## SSDA 8449 - Response to Submissions

Bays 5-15 Locomotive Workshop,  
Australian Technology Park, Eveleigh

Submitted to Department of Planning &  
Environment

12 June 2018 | 17068

**Figure 2 Visual Sightline zone**

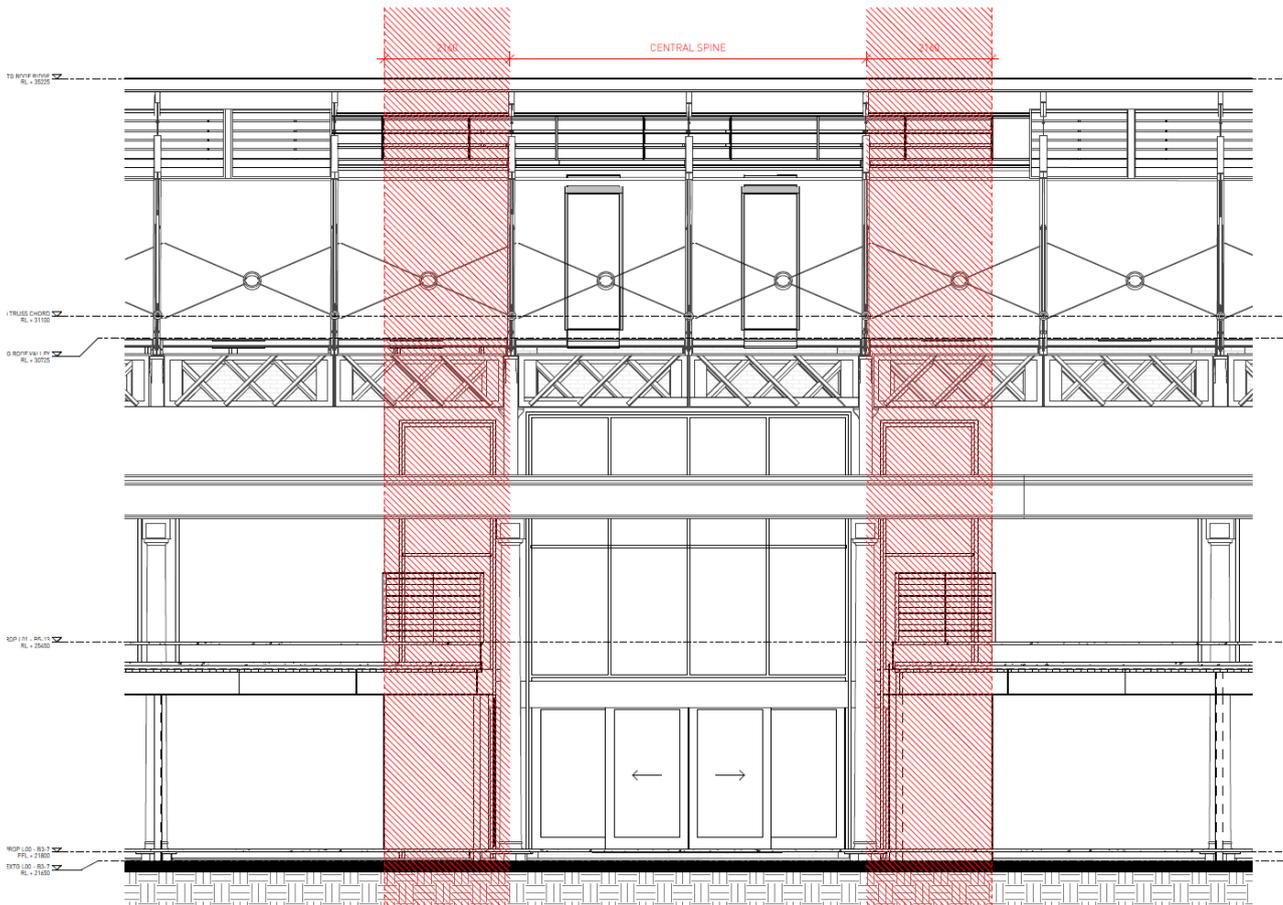
### Response

As set out in the EIS, and shown on the revised Architectural Plans, included at **Appendix C**, a Visual Sight Line zone (refer to **Figure 2**) has been established within Bays 5-7 at the Ground Floor level and Level 1. Within this zone, all balustrades on Level 1 will provide a transparent edge, in order to enhance the expansive views from Bay 4a towards the Bay 7/ Bay 8 wall (as shown in **Appendix H**).

- any tenancy walls and fit-outs within this 'zone' will be low height (maximum of 1850mm) open or transparent;
- the integration of the heritage collection items is encouraged into and features as part of the fit-out; and
- fit-out items must not cover or obscure the heritage structure or equipment.

**Figure 5** Proposed Ground Floor plan for Bays 5-15 – RTS submission

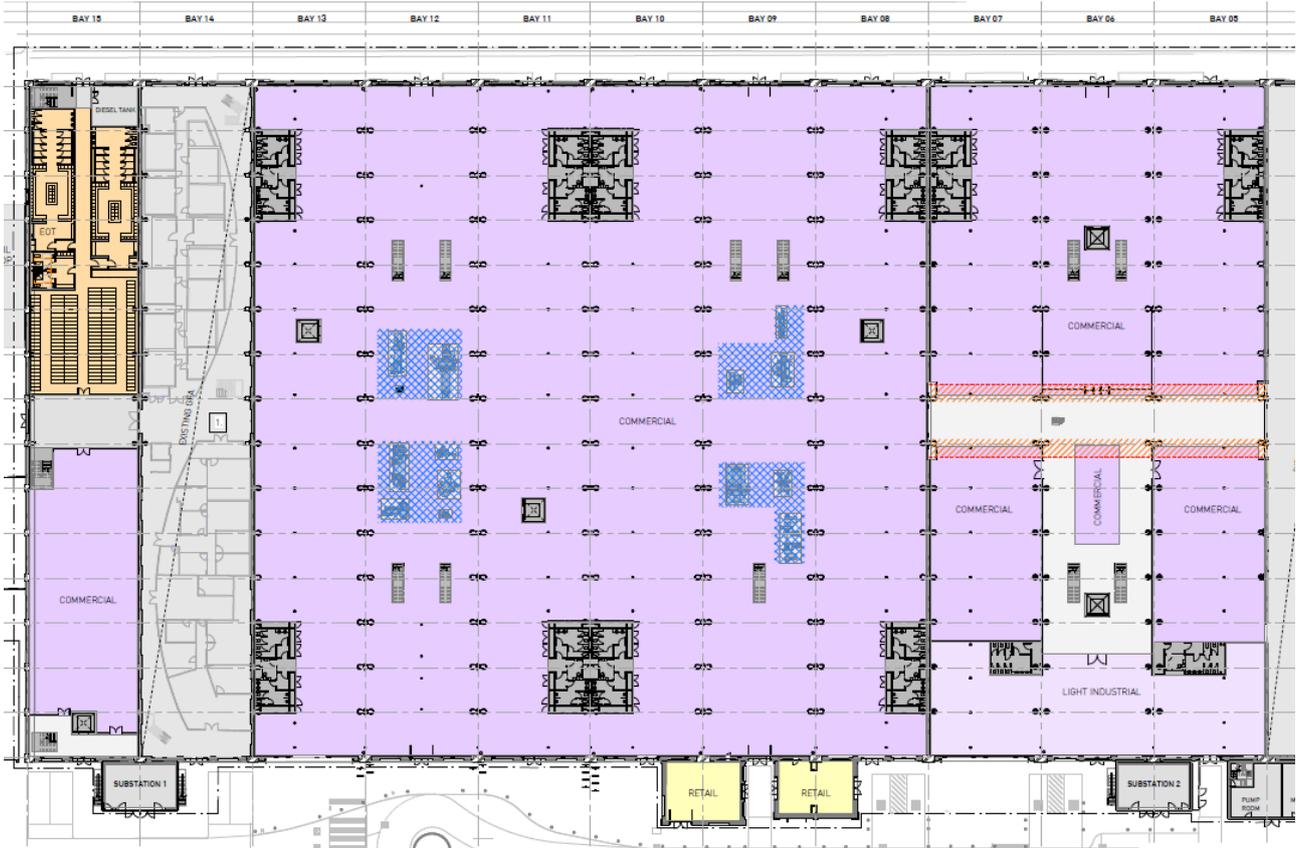
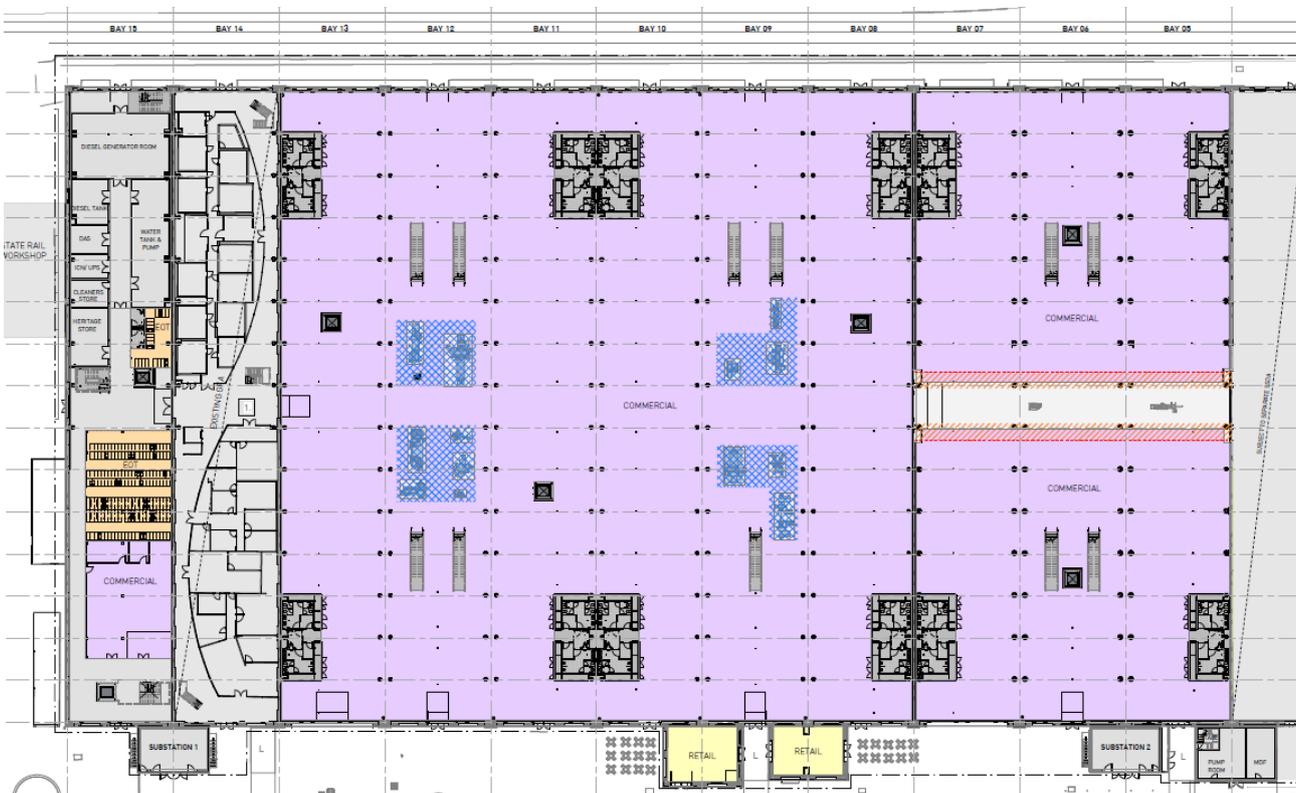
The revised grouping then evolved to form the arrangement that was submitted with the EIS as illustrated in **Figure 4**, **Figure 6** and **Figure 8**. However, the arrangement has been further refined as a result of the consideration of the submissions and design development. The revised arrangement is illustrated in **Figure 5**, **Figure 7** and **Figure 9**.

- Bay 15, which will provide:
  - a reduced commercial tenancy, circulation space, two bicycle storage areas providing a total of 184 bicycle spaces, and back of house and facilities rooms, two lift cores and stairs at Ground Floor level;

- a commercial tenancy, circulation space, End-Of-Trip changing facilities, lift cores, stairs and plant at Level 1;
  - a commercial tenancy, circulation space, stairs and lift core within the southern portion of Level 2.

The revised design of Bay 15 requires a greater area of the Ground Floor Level of Bay 15 to be allocated to plant equipment. In order to accommodate the additional plant equipment, the end-of trip and bicycle storage rooms have been reduced in size which results in a reduction to the number of bicycle spaces that can physically be accommodated. The revised design therefore only allows 184 spaces to be provided.

Mirvac are committed to encouraging cycling as a key mode of transport for the ATP precinct, however the requirement to provide the significant additional plant as illustrated in **Figure 5** results in a reduction to the size of the bicycle parking and end of trip rooms in Bay 15 and therefore there is not enough space to accommodate the number of bicycle racks that were originally anticipated. Notwithstanding this, the provision of 184 bicycle spaces for the employees within the Locomotive Workshop is considered acceptable as the ATP precinct has a high level of accessibility from public transport and the proposed number of spaces are in accordance with the Green Star targets.

**Figure 12 3D sectional view of the proposed Plant Platforms**

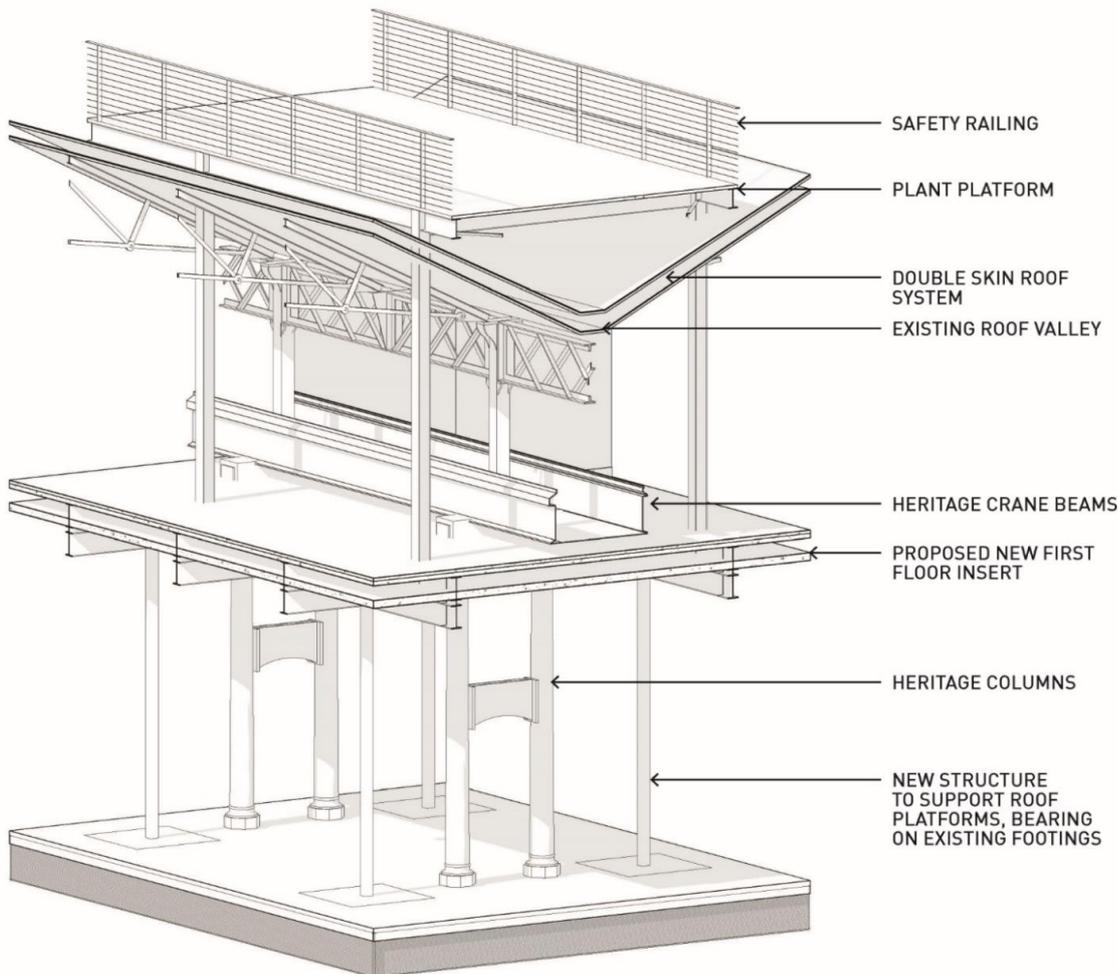
- the introduction of additional structural support (if necessary) for the roof;
- external enclosures, such as the sub-stations;
- the introduction of new structure for the roof plants; and

The revised design includes a new platform to support roof plant within the roof valley between Bays 14 and 15. It is to be accessed via new access stairs that will lead from the fire egress stairs in Bay 15 and will be of steel construction, supported by new columns that will transfer the load to bear on the supports for the new Level 1 floor structure (refer to **Figure 12**). The detailed design drawings of the roof platforms and their structural supports will be included within the construction certificate documentation for CC3 – Structure.

The positioning of the plant platforms has been carefully considered to ensure that they are located where visibility is limited from street level or from people on passing trains.
